ABBREVIATED PLAT AGENDA

September 24, 2025

STAFF REVIEW AND RECOMMENDATIONS
PUBLIC HEARING
SEPTEMBER 17, 2025

ABBREVIATED PLAT: HARDCREST

DRAWN BY ICAD/K.Lyne	DATE 7/28/25	DRAWING: 2025-5/JewelsAcres2025
CHECKED BY GLo	SCALE 1 INCH = 50 FEET	SHEET 1 OF 1

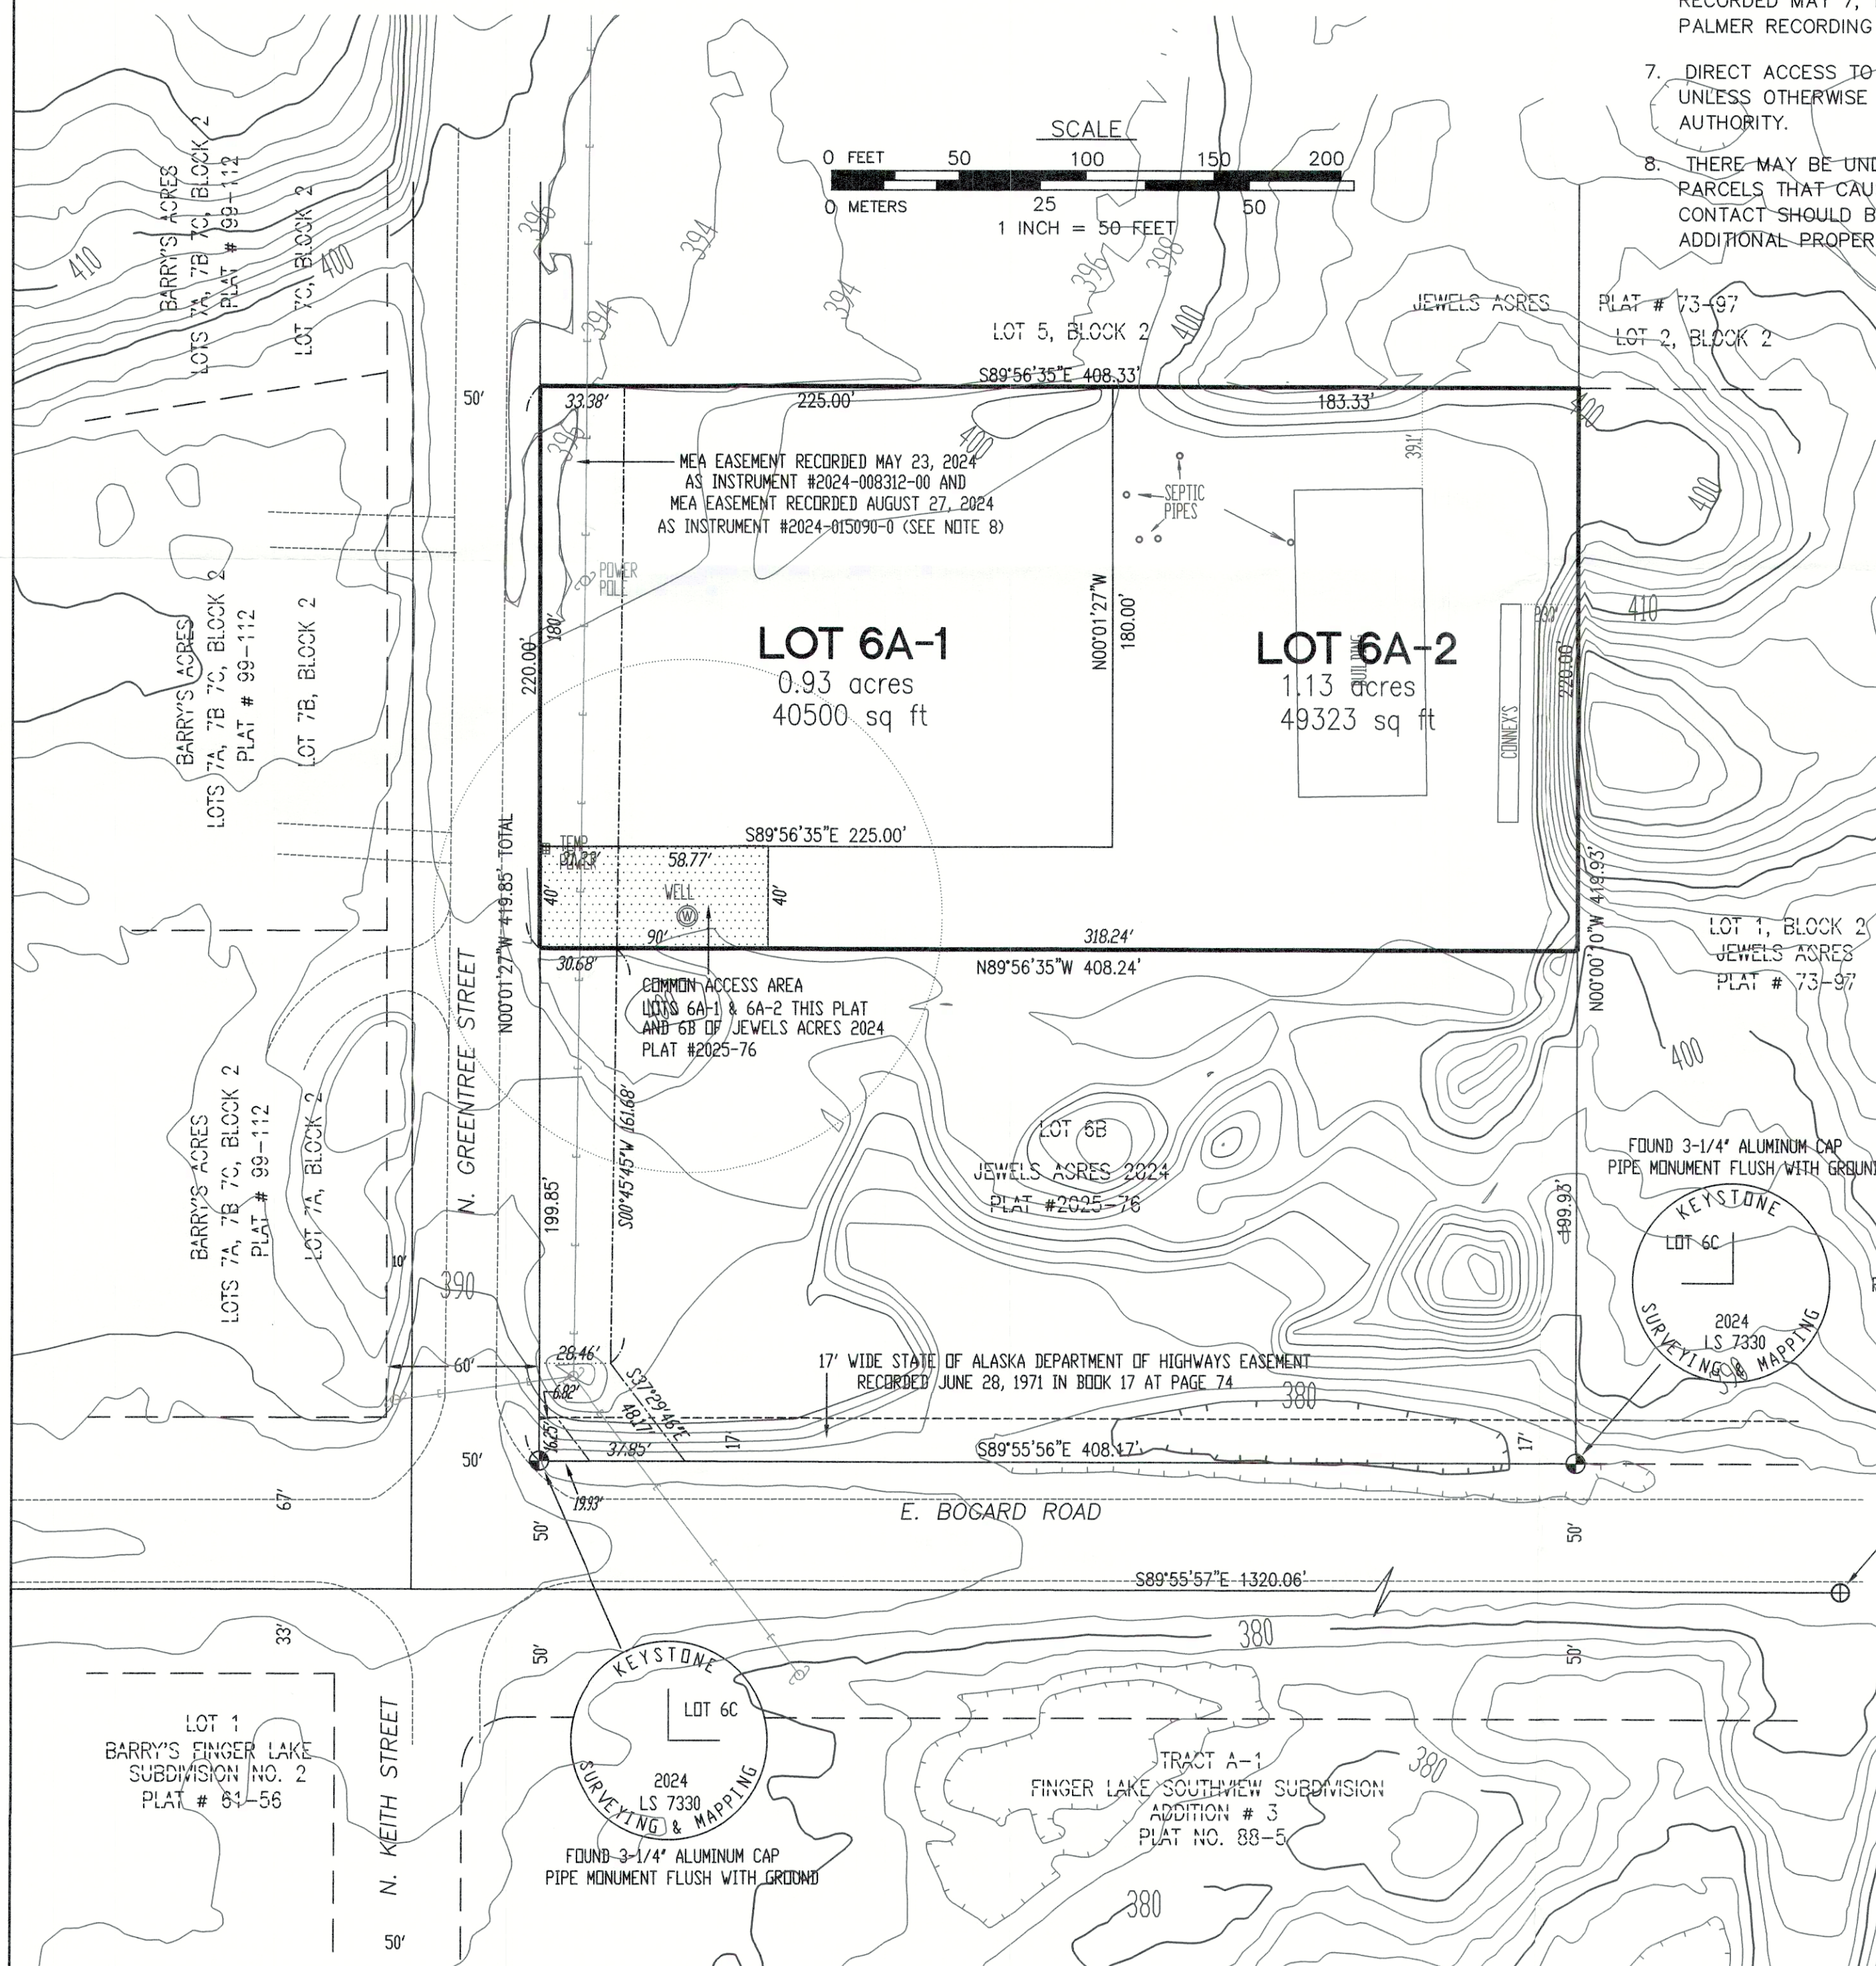
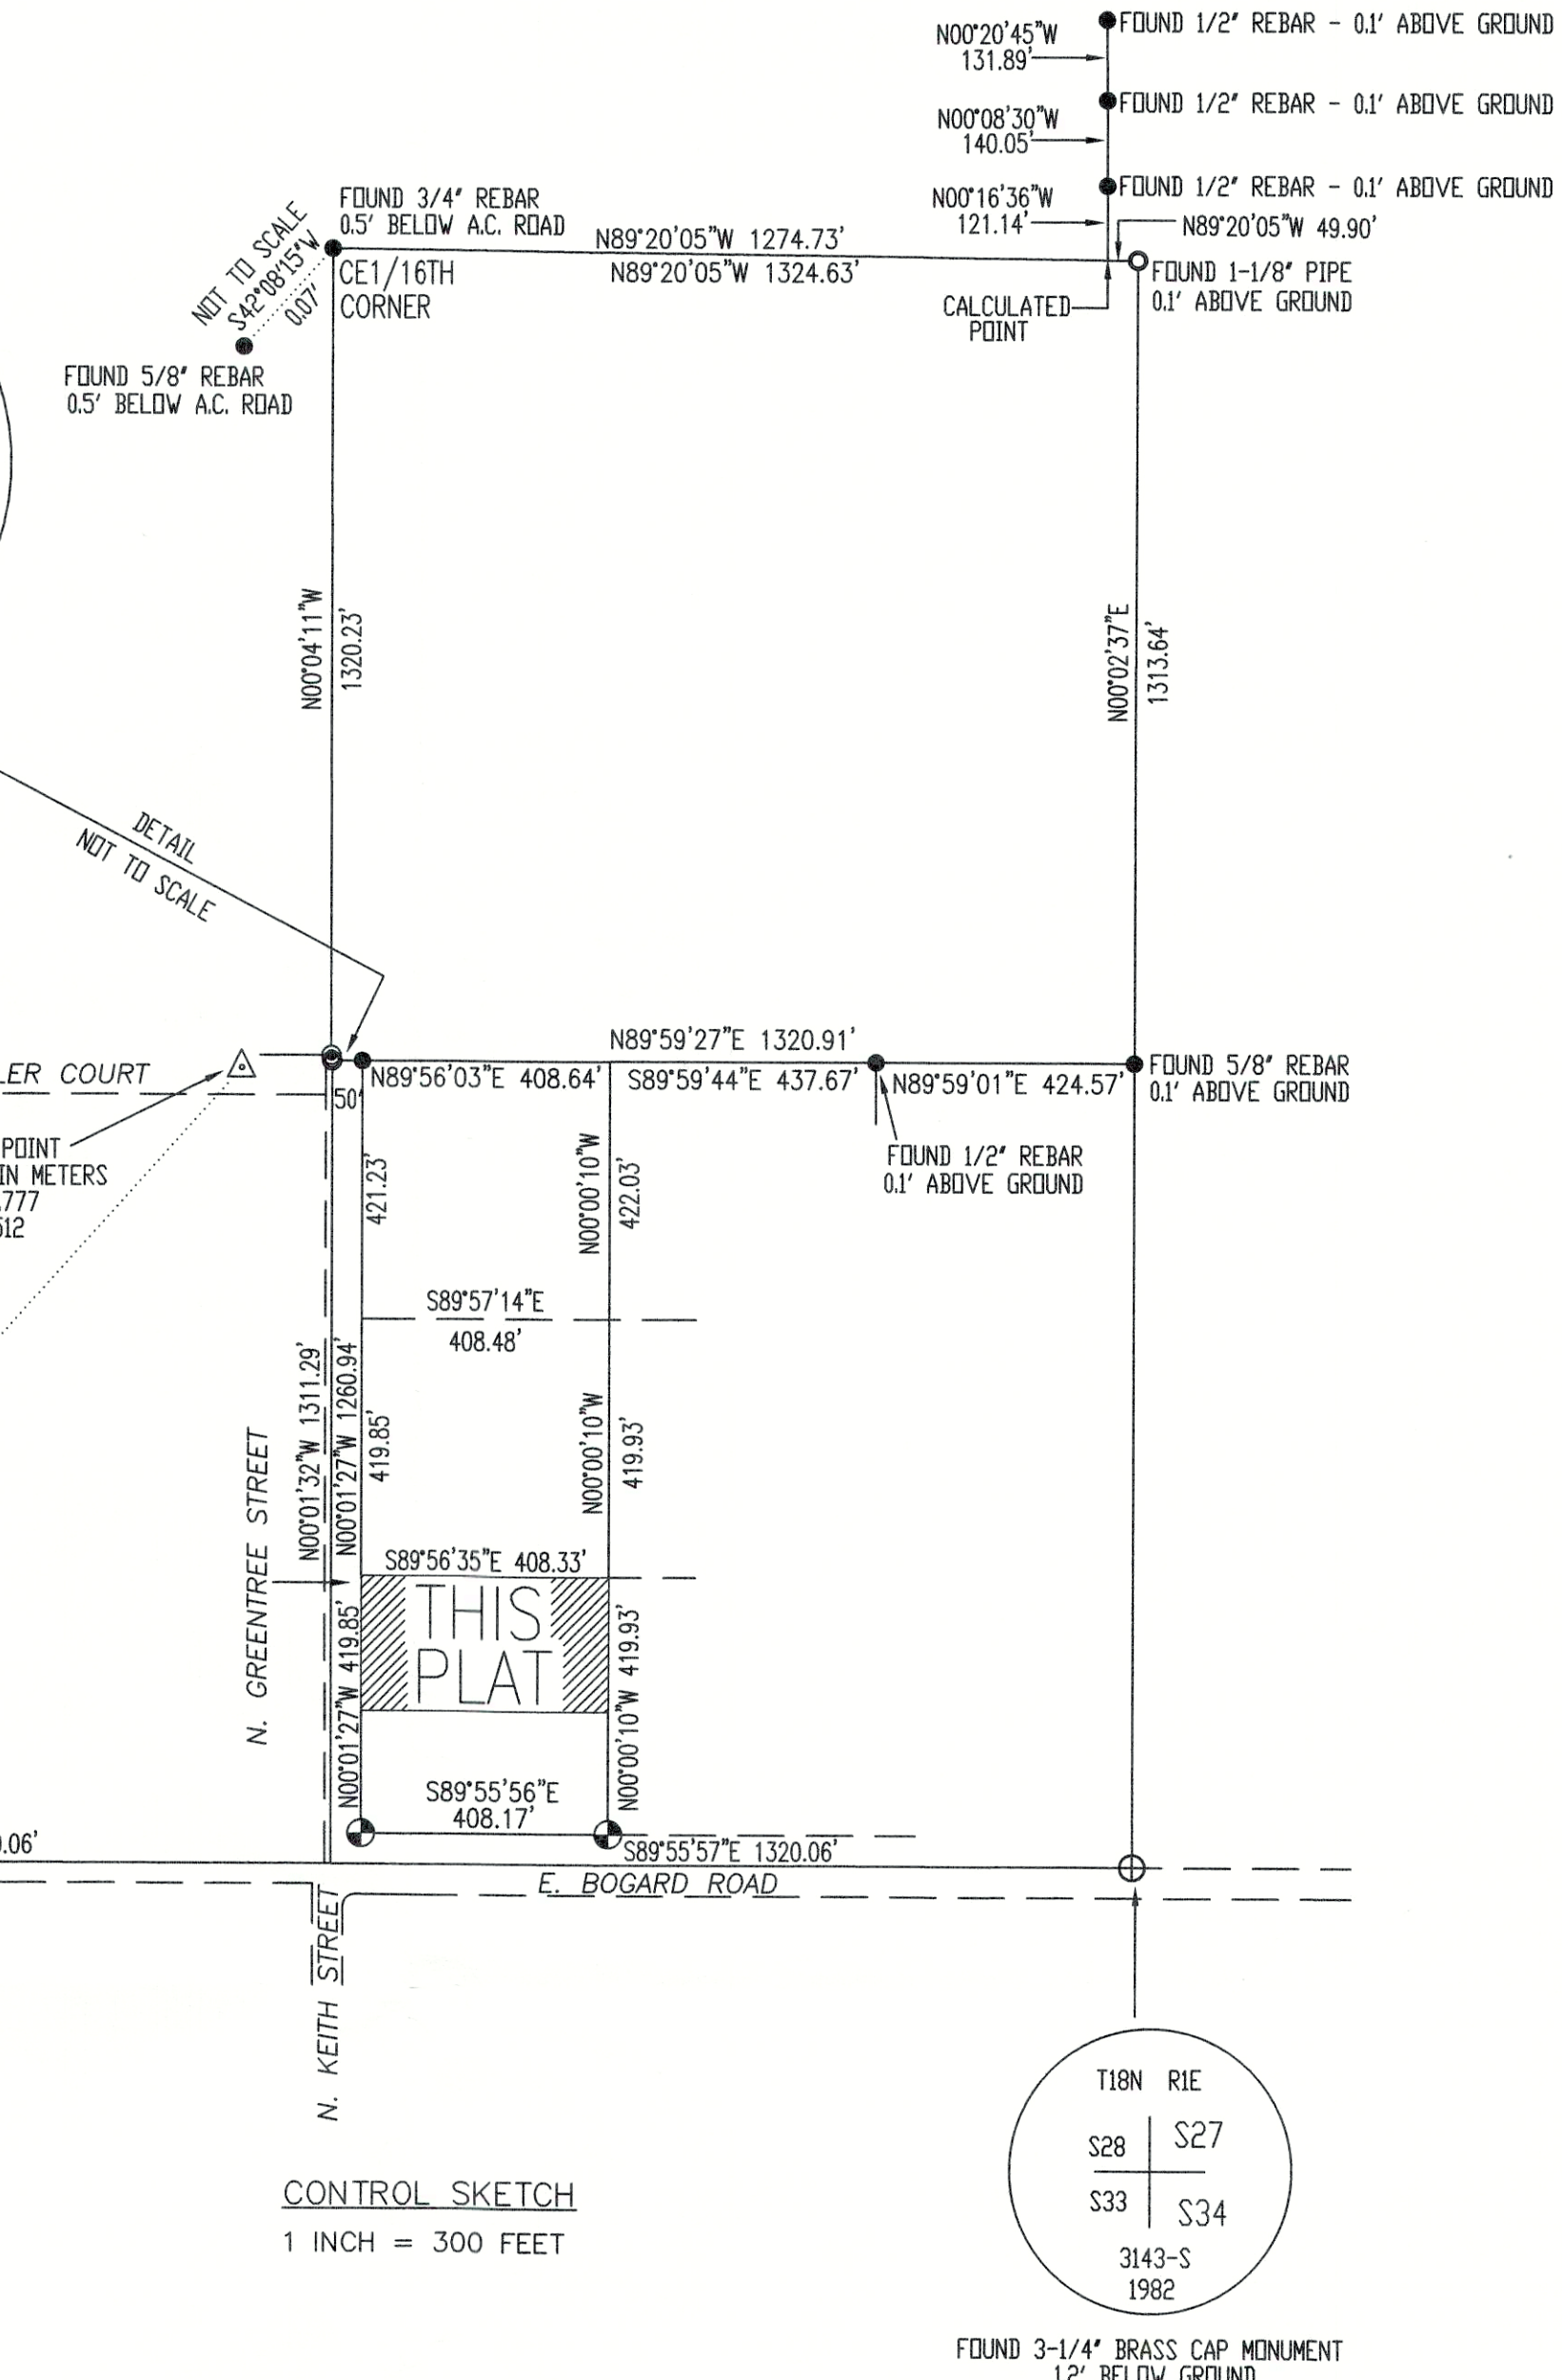
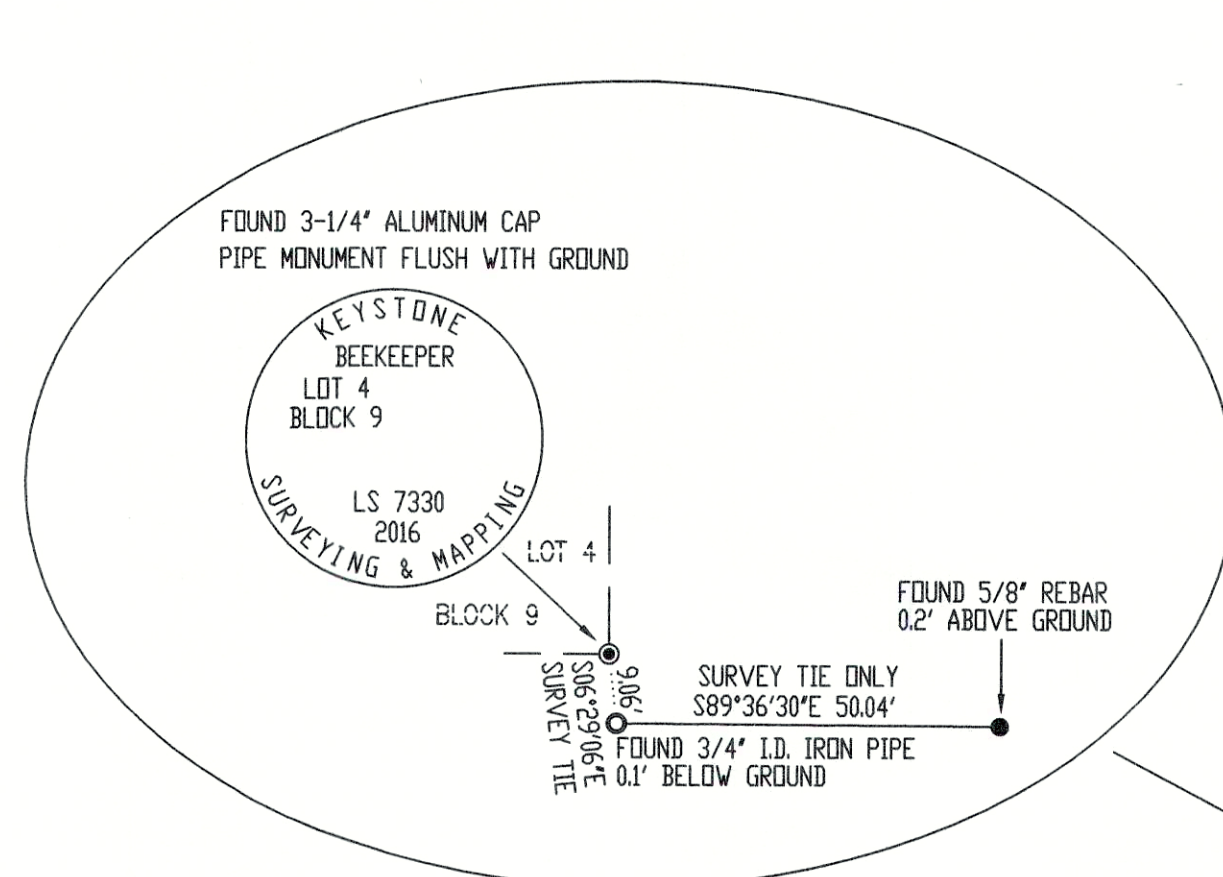
North Lakes Community Council (**Exhibit F**) notes that the Borough Assembly recently approved the Bogard-Seldon Corridor Access Management Plan (CAMP). Now that this plan is adopted, there are obligations of the Platting Department that must be considered for any such development. Specifically, Section 5.3 of the approved CAMP states:

1. No additional Driveways to Bogard Road. This has already been addressed with a note on the agenda plat.
2. The intersection of Greentree onto Bogard, as envisioned by the CAMP, will include left turn lanes on Bogard Road. We are unsure if there will be any left or right turn lane provided on Greentree at that intersection. If so, is there any potential ROW impact to the subject property? This issue should be mentioned and definitively addressed as part of this platting action.
3. Of most significance, is the intended Minor Collector Street planned between North Greentree and North Burlwood. The plan is for Burlwood to no longer have access on to Bogard Road. It is to end in a cul-de-sac. A new minor collector street is planned that will run east-west along the northern property boundary of lots 6A-1 and 6A-2 of the proposed

1. No additional driveway access to Bogard Road. This has been already been addressed with a note on the Agenda Plat.
2. The intersection of Greentree onto Bogard, as envisioned in the CAMP, will include left turn lanes on Bogard Road. We are unsure if there will be any left or right turn lane provided on Greentree at that intersection. If so, is there any potential ROW impact to the subject property? This issue should be mentioned and definitively addressed as part of this platting action.
3. Of most significance, is the intended Minor Collector Street planned between North Greentree and North Burlwood. The plan is for Burlwood to no longer have access on to Bogard Road. It is to end in a

cul-de-sac. A new minor collector street is planned that will run east-west along the northern property boundary of lots 6A-1 and 6A-2 of the proposed subdivision. Plat approval for the subdivision must address the necessary road right-of-way and utility easements along this property line.

Platting staff notes that the concerns raised by the North Lakes Community Council were reviewed and the proposed Jewels Acres 2025 does not conflict with the Bogard Seldon Corridor Access Management Plan.

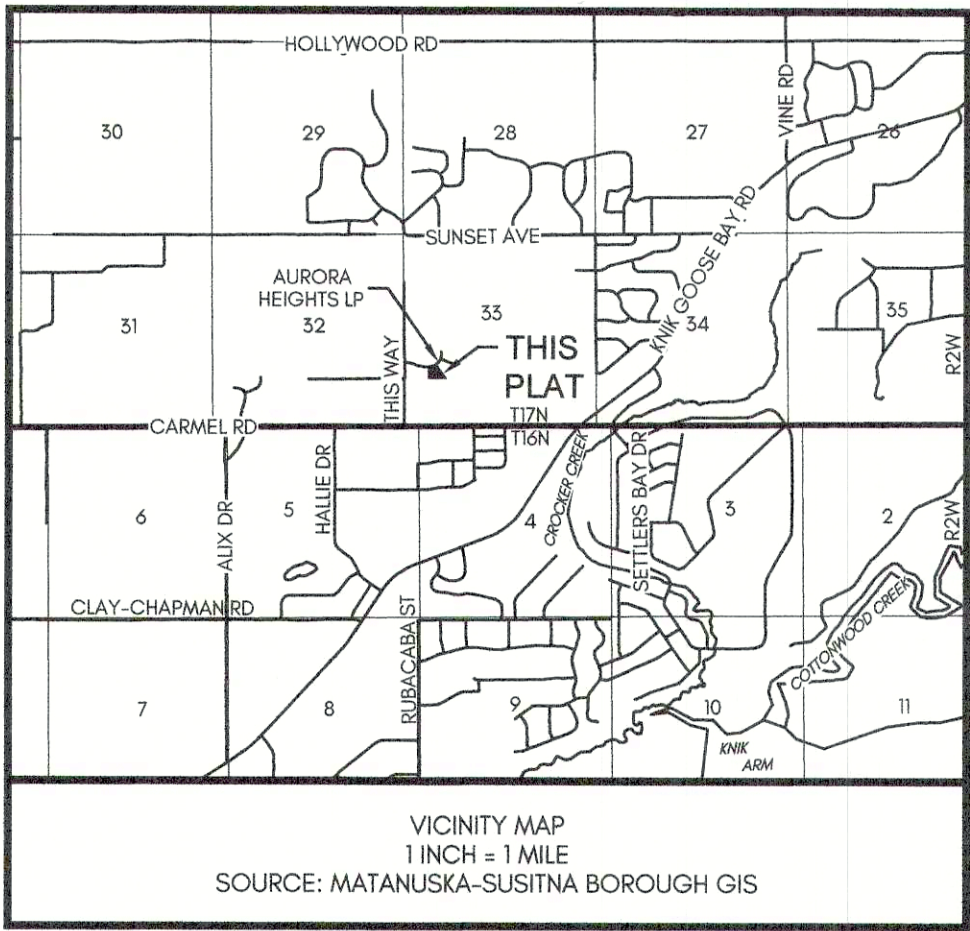
In review GCI has no objections, only the following comment for the attached signed plat.
The legal description in the title block needs to show the SECTION to be 33, Township to be 17N and Range to be 2W.
